## CERTIFICATE OF APPROPRIATENESS

**Applicant:** Gail Schorre, Morningside Architects LLP for Jonathan & Louise Holley, owner

**Property:** 619 Woodland Street, Tracts 11 & 12A, Block 28, Woodland Heights Subdivision. The property includes a historic 1,182 square foot, one-story wood frame single-family residence and a detached garage situated on a 5,000 square foot (50' x 100') interior lot.

**Proposal:** Alteration – Construct a rear side one-story side addition and a second story addition to a one-story residence.

**EAST SIDE ELEVATION**

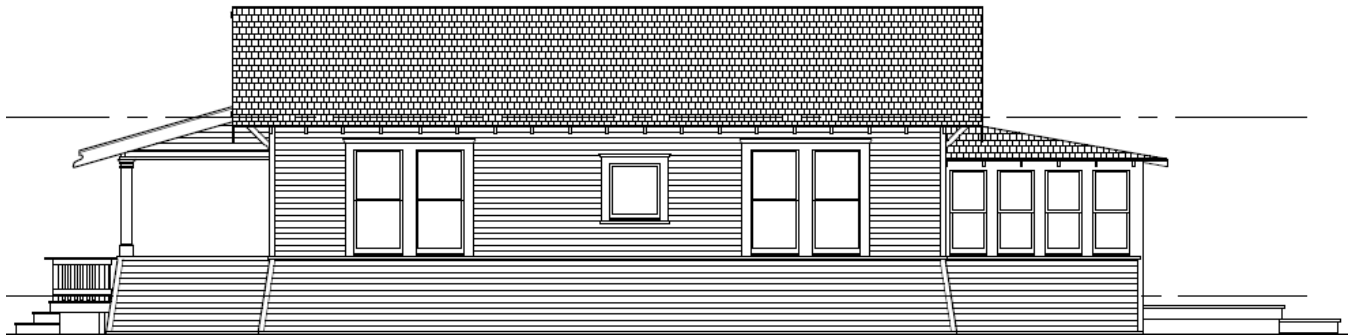
**Side Elevation:** A ribbon of four 1-over-1 sash windows will be raised so the window headers will be in line with the other existing window headers on the east elevation.  
(East)

**NORTH (REAR) ELEVATION**

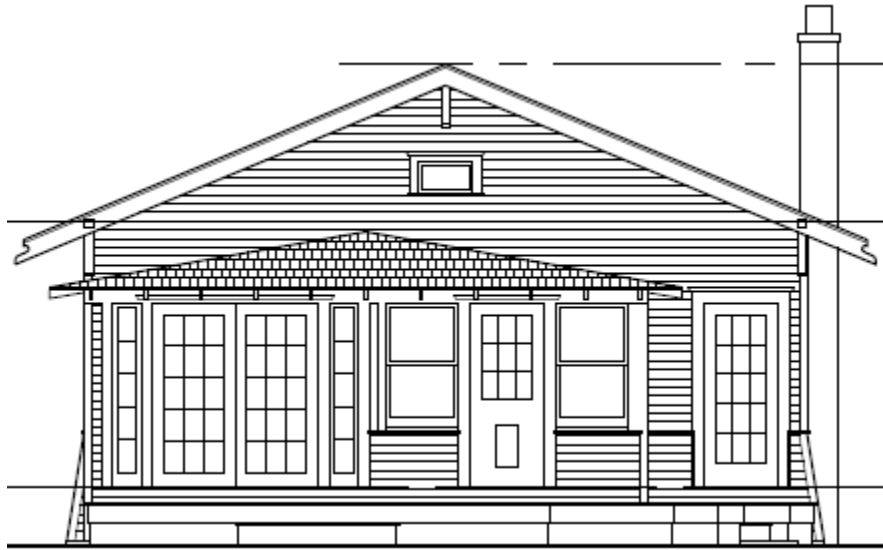
**Rear Elevation:** A non-original divided lite french door with divide lite side lites will be replaced with two 1-over-1 sash windows and two existing 1-over-1 sash windows will be relocated on the rear elevation to create a ribbon of four 1-over-1 sash windows.  
(North)
